TOWN OF NEWBURGH PLANNING BOARD TECHNICAL REVIEW COMMENTS

PROJECT: BJ'S WHOLESALE CLUB-NEWBURGH

PROJECT NO.: 19-07

REVIEW DATE: 30 MAY 2019 MEETING DATE: 6 JUNE 2019

SOIL EROSION & SEDIMENT CONTROL PLAN

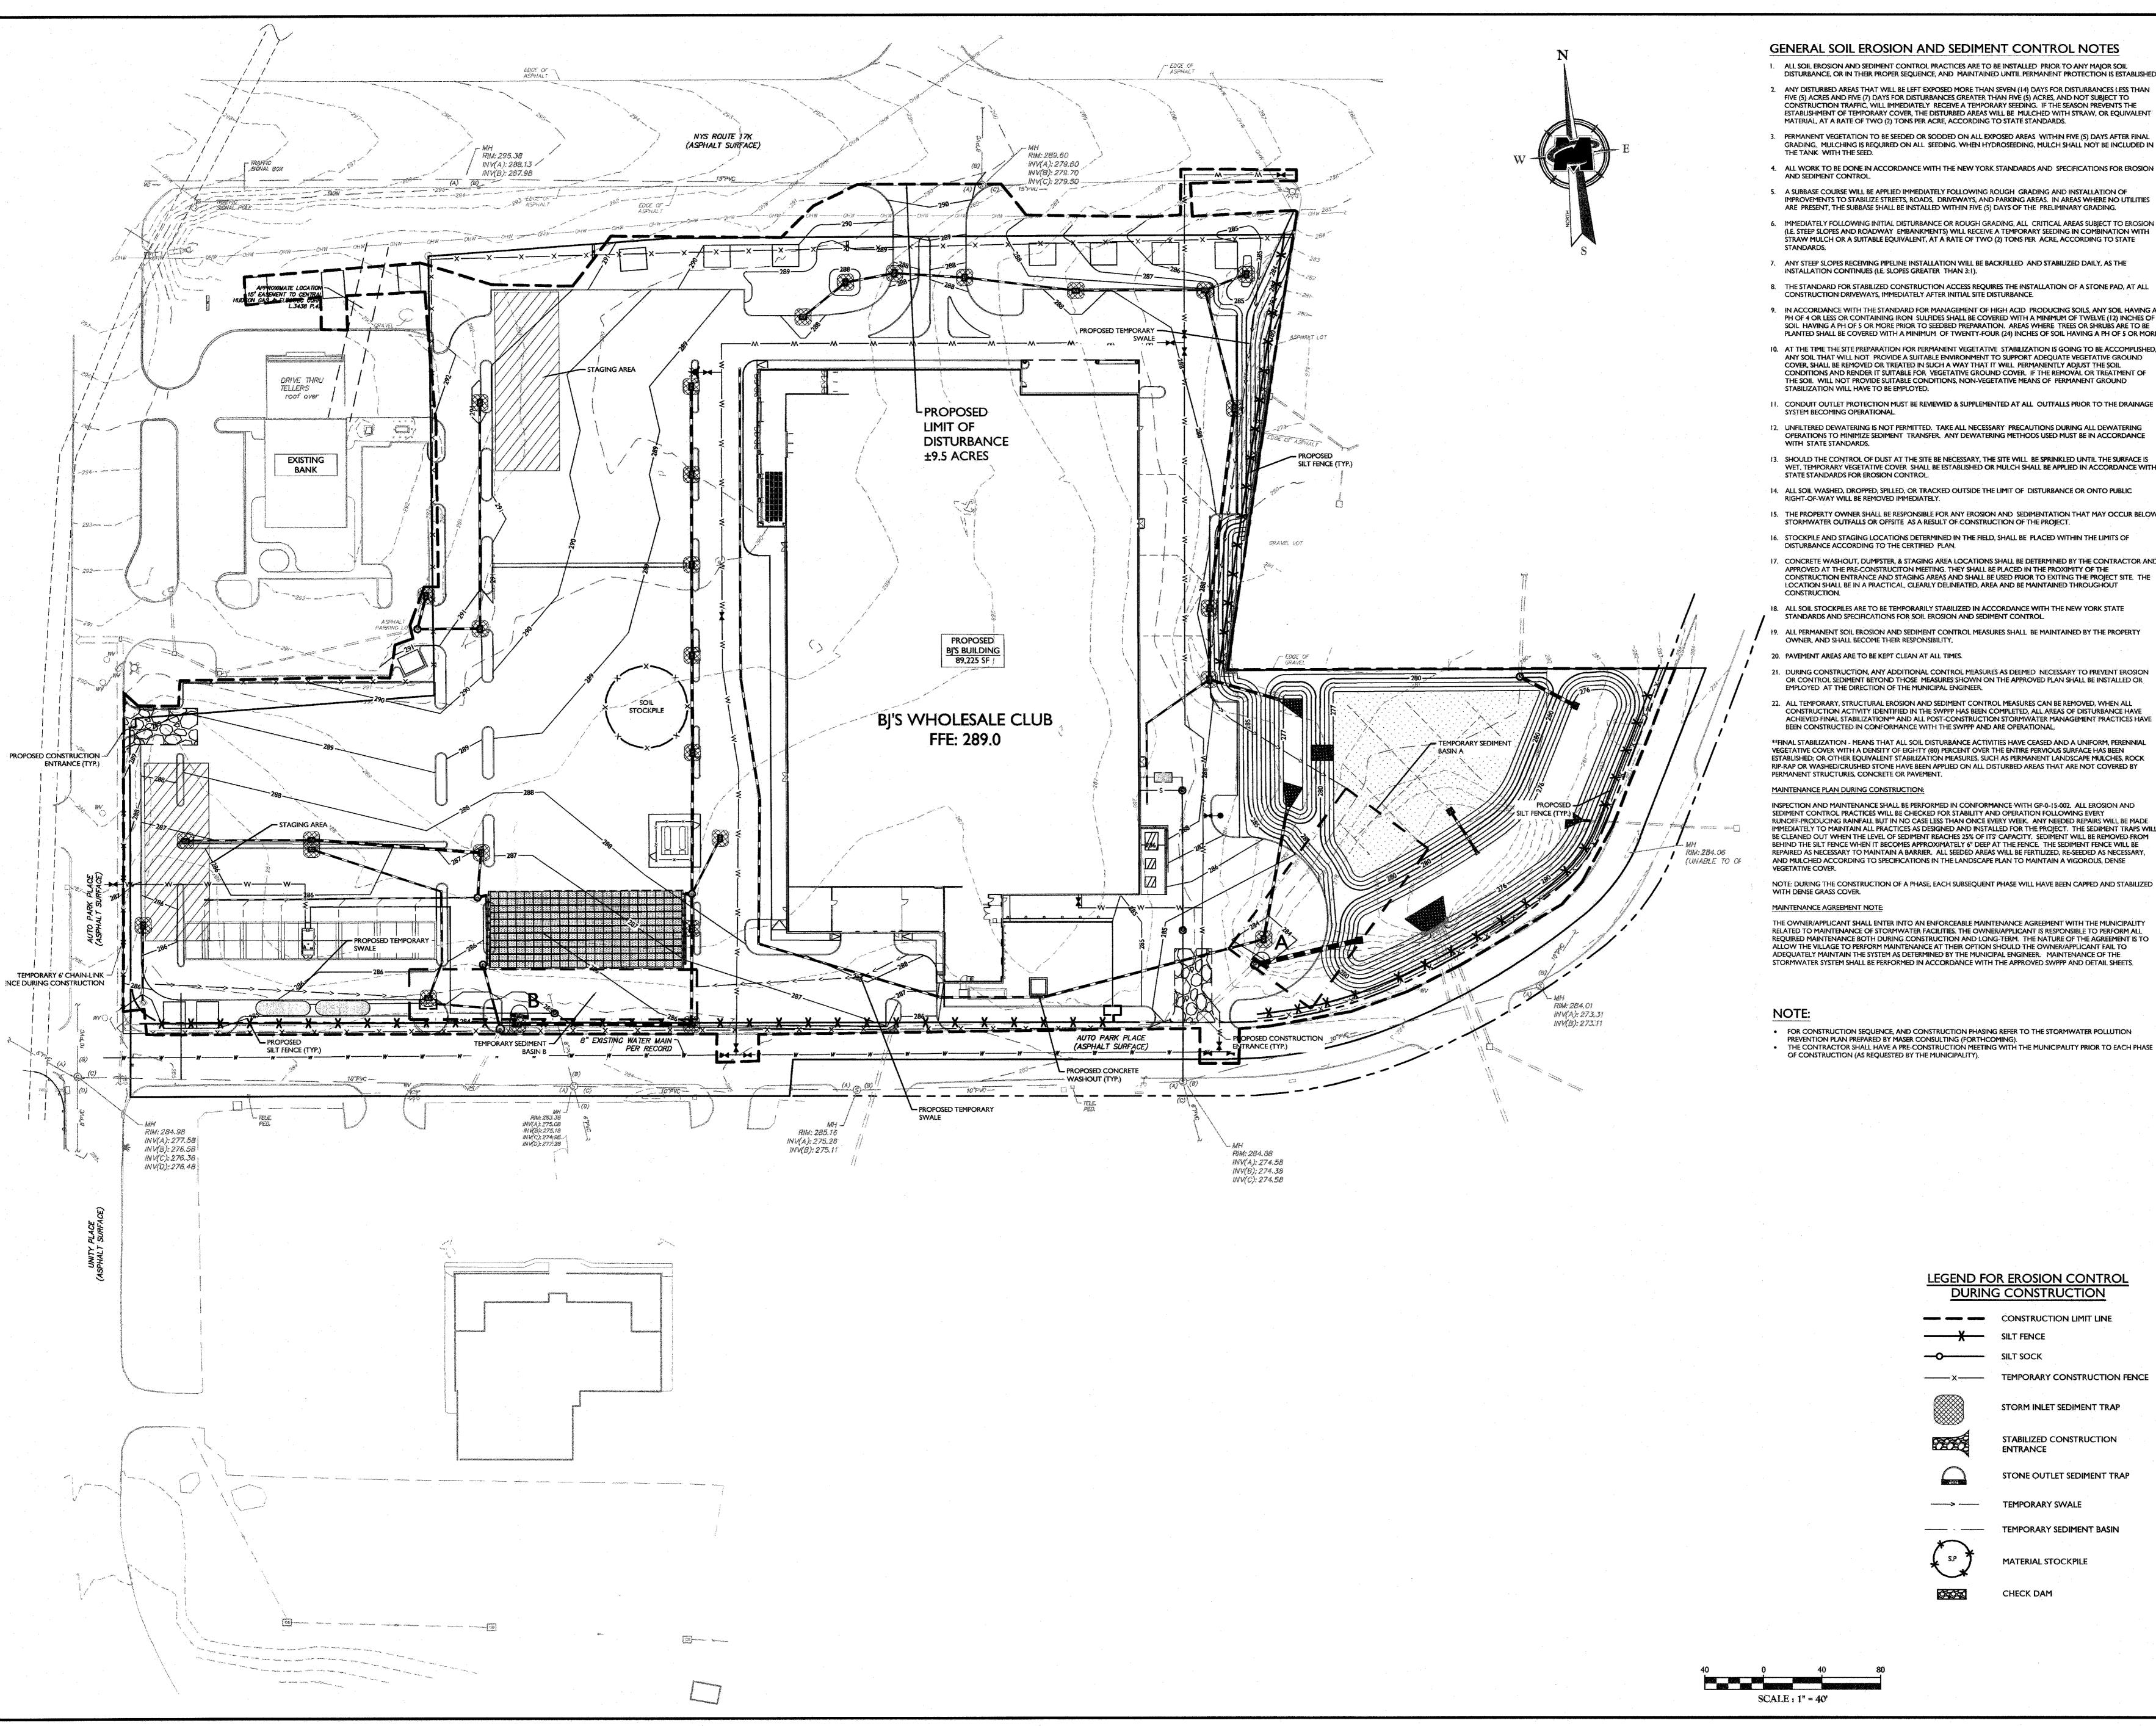
- **6.** The Applicant's representative requested to evaluate the location of a temporary sediment basin A as an existing stormwater management piping and facilities are located within this area.

BIORETENTION SYSTEM CROSS SECTION

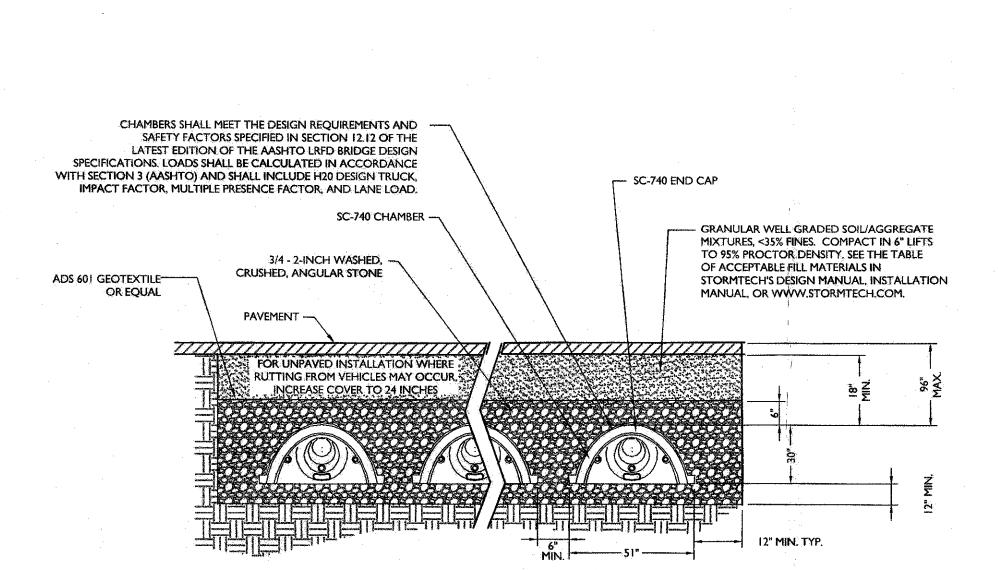
- **7.** The bio retention system cross section identifies Outlet Control Structure detail this sheet. No outlet control structure detail is depicted.
 - Regional Office 111 Wheatfield Drive Suite 1 Milford, Pennsylvania 18337 570-296-2765 •
